The Downtown Carpark Redevelopment

[FTAA-2512-1158]

MEMORANDUM OF PLANNING MATTERS FOR AUCKLAND COUNCIL

Dated: 7 May 2026

Figure 11: Road closures and pedestrian routes during demolition and construction

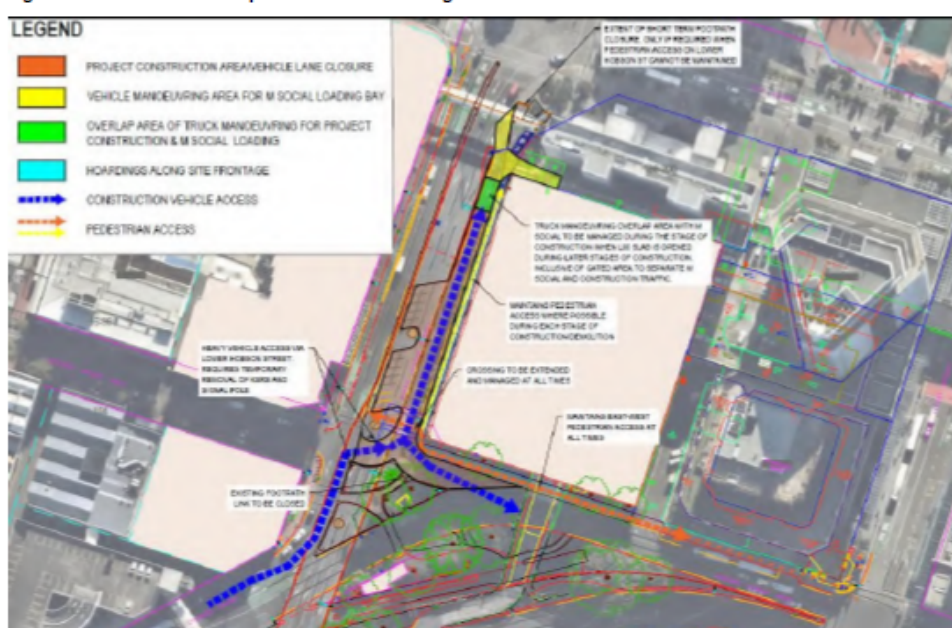
331. Generally standard construction hours are proposed with the exception of demolition stages (a. and c. noted above) requiring full road closures to minimize weekday effects on the transport network. This approach is supported by Auckland Transport (**Annexure 4**).

The Demolition and Construction Transport Assessment, includes a plan of road closures and pedestrian routes during demolition and construction provided below, for ease of context to the Panel.

Figure 1: New option for east-west pedestrian connection on Customs Street West

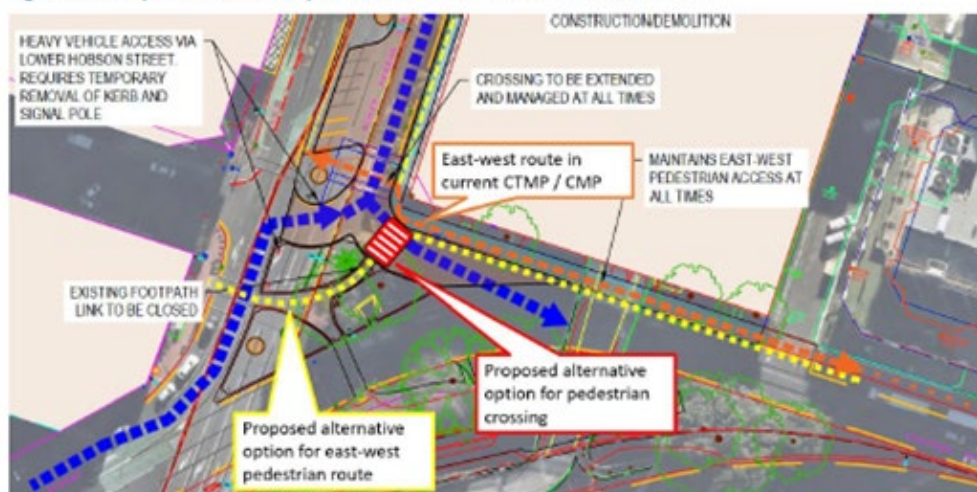
332. Further to the above, a refined approach to the road closures and pedestrian routes was provided in the Transport Addendum, provided below for comparison. This is noted to reduce potential pedestrian / construction vehicle conflicts, improving management

efficiency for vehicle access from beneath the Flyover efficiently and is supported by Auckland Transport⁸⁸.
